## RAI 2-2

### AREVA Response:

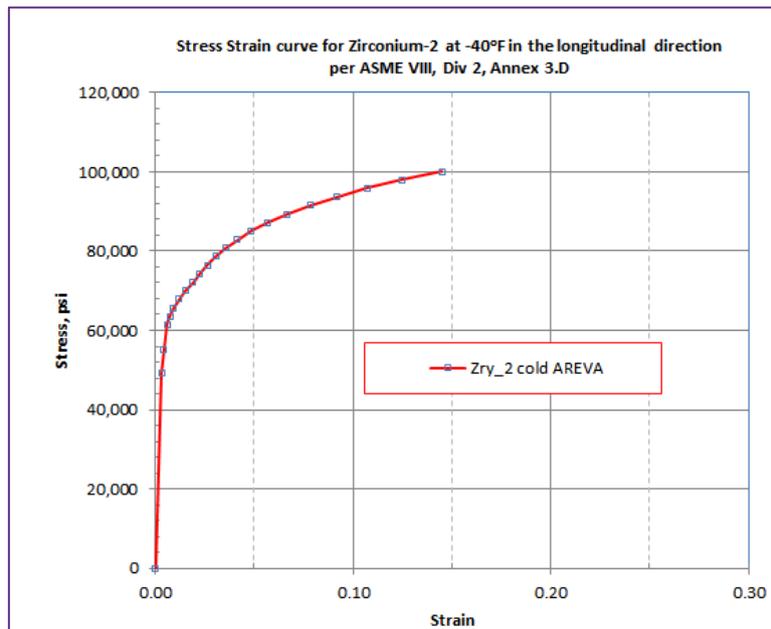
The main issue of this RAI is related to the linear and non-linear behavior of the cladding materials, as the applicant expected some plastic deformations. The staff asked where deformations of the cladding materials of the ATRIUM-11 fuel, under the accident conditions, would fall in its deformation versus strength curve. The applicant replied that the cladding material would have a 14% strain corresponding to the ultimate strength and added that the maximum strain of the cladding material after the 30 feet drop was 2.5%. The applicant also explained that it used a margin of safety of 1.4 for the theoretical load for the dynamic analysis of the fuel bundle, imposed a velocity at impact in the model, and determined the deceleration history. The staff asked the applicant to explain what is meant by applying an acceleration time history if an impact velocity is imposed and how they performed the dynamic analysis. The staff also asked the applicant to provide the assumptions used in the dynamic analyses (with rationales) and both the strain curve for Zirc-2 and the applicable references as part of the response.

The development of the stress-strain curves for the Zircaloy-2 cladding material is detailed in page 16, Section 7.3.1 of Reference 2-2-1. The stress-strain curve material model at -40°F for the cladding used in the fuel bundle analysis is represented by Figure 7.3.1-1 in page 17 of the same reference that it is shown below.

The minimum ultimate strain of the material Zirconium used for the end plug and the cladding is 14% per page 23, Figure 16, of "Review of Zircaloy-2 and Zircaloy-4 Properties Relevant to N.S. Savannah Reactor Design, Whitmarsh, C.L. July 9, 1962, ORNL-3281, UC-80-Reactor Technology, TID-4500, 17th Ed".. The result of the current fuel bundle drop analysis shows that the maximum plastic strain of 2.6% in the fuel cladding occurs at the weld of the heat-affected zone as shown in page B7, Figure B.5.1-2 of Reference 2-2-2. The strain plot is presented below. The maximum strain of 2.6% in the fuel rod is much less than the ultimate strain of 14% for the material Zirc-2.
